MONTICELLO NUCLEAR GENERATING PLANT
DOCKET NO. 50-263 LICENSE NO. DPR-22

Draft Interim Technical Specifications
Radioactive Effluents

List of Monticello Appendix A
Technical Specifications that
Must be Deleted or Changed Upon
Issuance of TS.B.2.4, Radioactive Effluents

TS B.2.4-RADIOACTIVE EFFLUENTS

Figure TS B.2.4-1 Off-Gas Storage Tank Gross Activity Limits

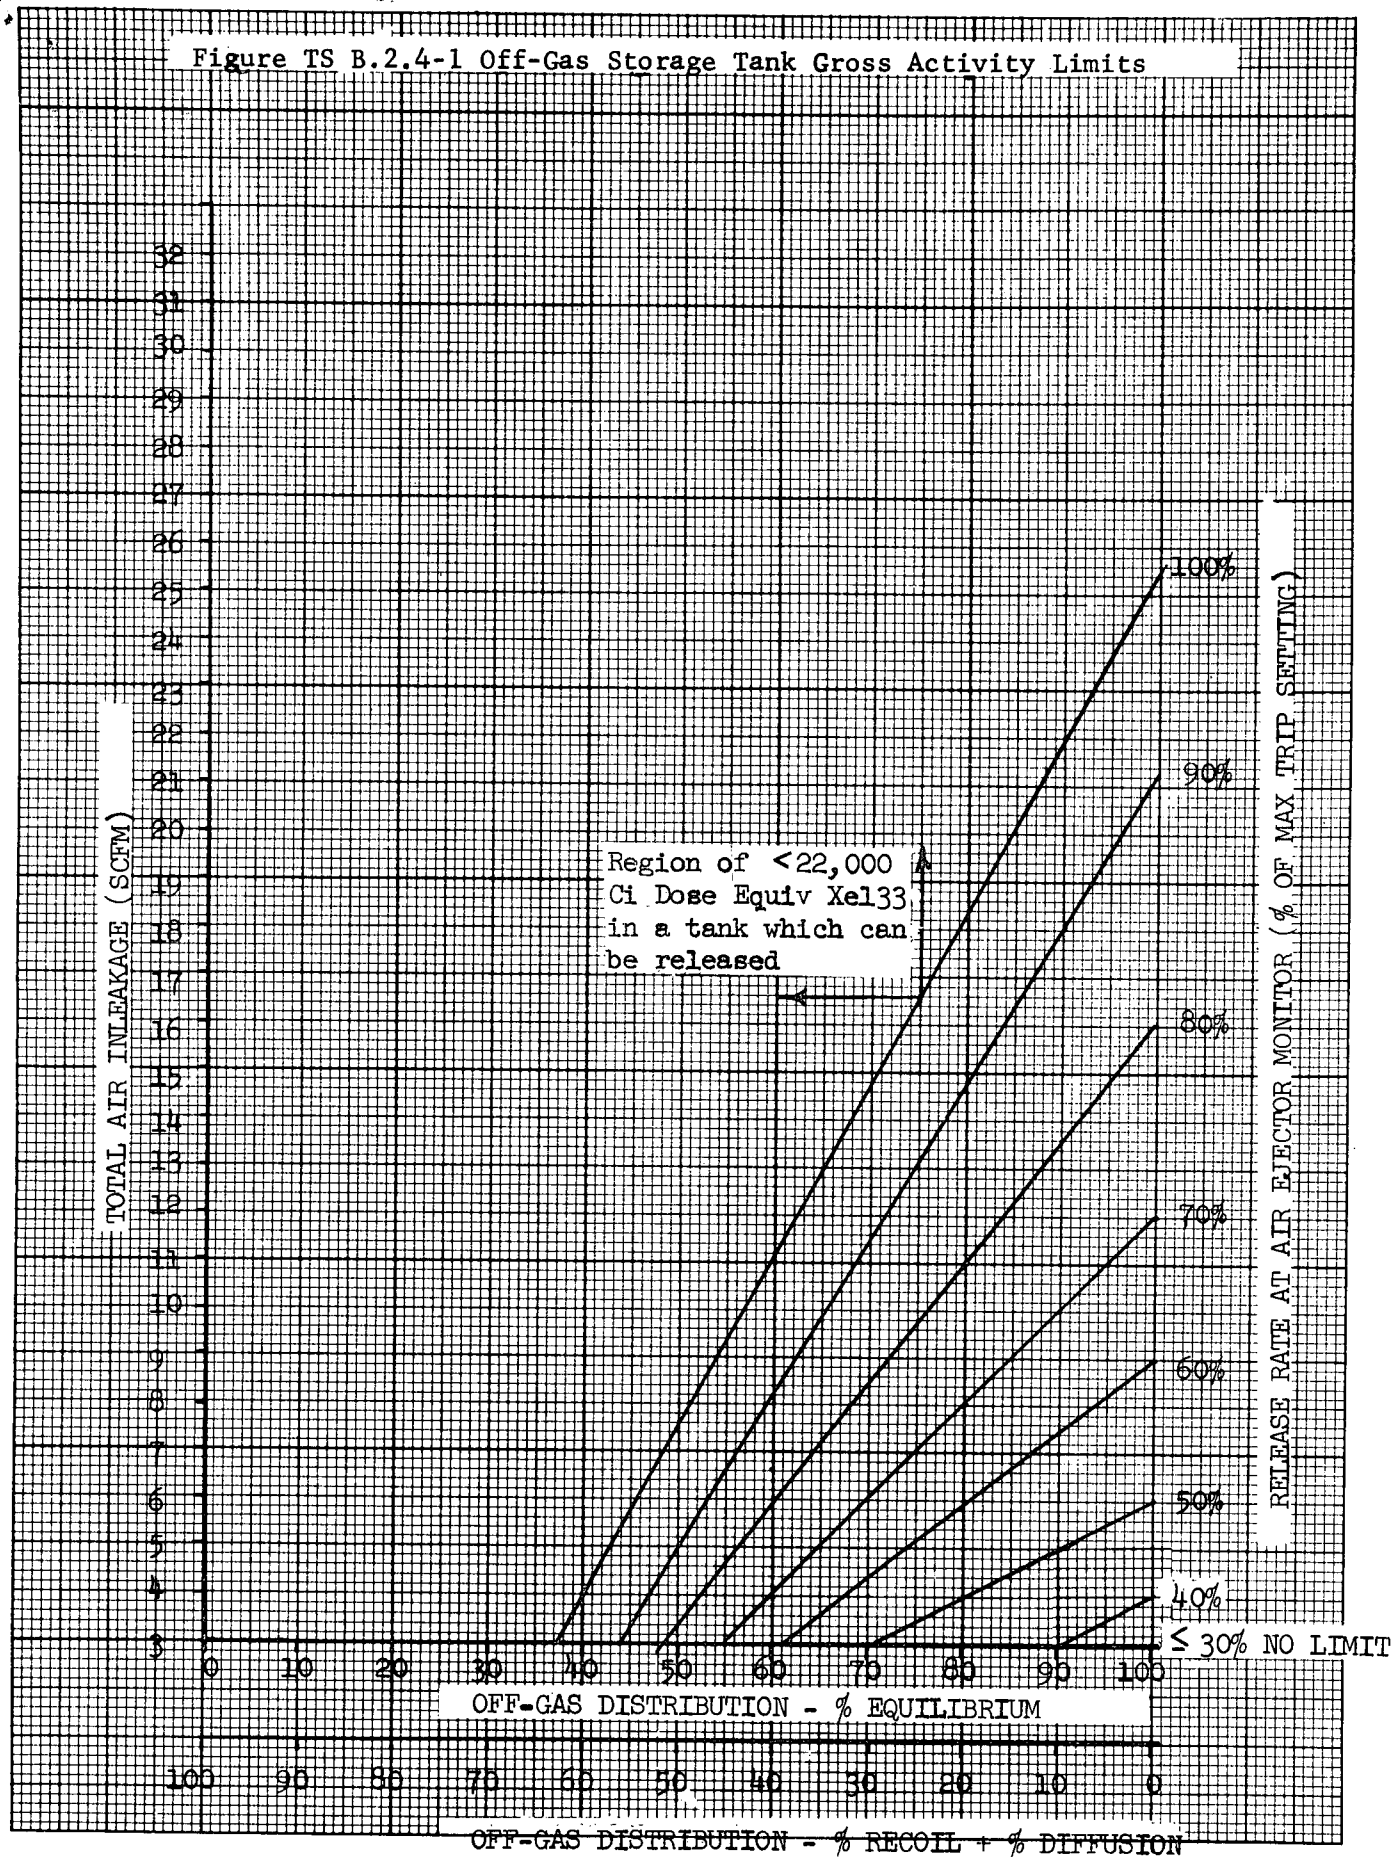
Calculations have been performed to determine the relationship between steam jet air ejector offgas activity and composition and condenser air inleakage. These calculations were used to determine the curves presented in Figure 2.4-1. The results of the measurement of condenser air inleakage and the average air ejector offgas release rate are used in conjunction with the

most recent offgas isotopic analysis to determine if the maximum permitted Xe-133 dose equivalent tank radioactivity contents may be exceeded. This analysis is adequate to initiate corrective action in the unlikely event that the tank radioactivity limit is being approached.

- j. The maximum gross radioactivity contained in one gas decay tank after 12 hours holdup that can be discharged directly to the environs shall be less than 22,000 curies of Xe-133 dose equivalent.
- k. The mechanical condenser vacuum pump shall be capable of being isolated and secured on a signal of high radioactivity whenever the main steam line isolation valves are open or it shall be isolated.
- l. At least once during each operating cycle automatic isolation of the mechanical condenser vacuum pump shall be verified.
- m. An unplanned or uncontrolled offsite release of radioactive materials in gaseous effluents in excess of 5 curies of noble gas or 0.02 curie of radioiodine in any one hour period shall be reported within 30 days.
